**Notice of Allowability**

10/775,851

PONZIANI ET AL.

FIG 19A

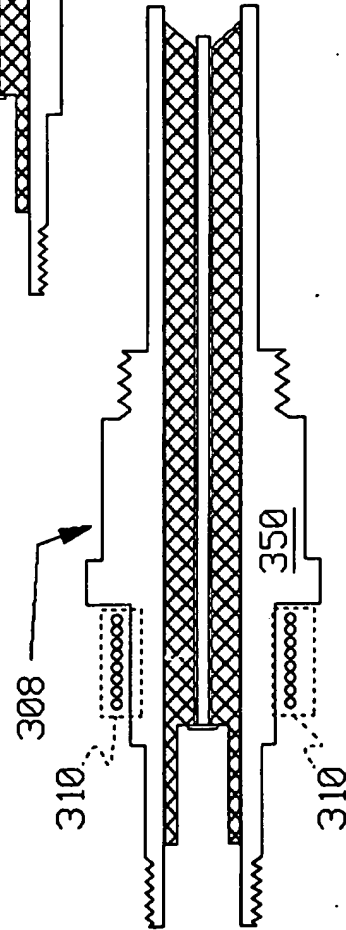
In the drawing, Fig. 19 A, added reference numeral 311 (see attached drawing correction).

Approved  
 A Deb  
 5/30/2006
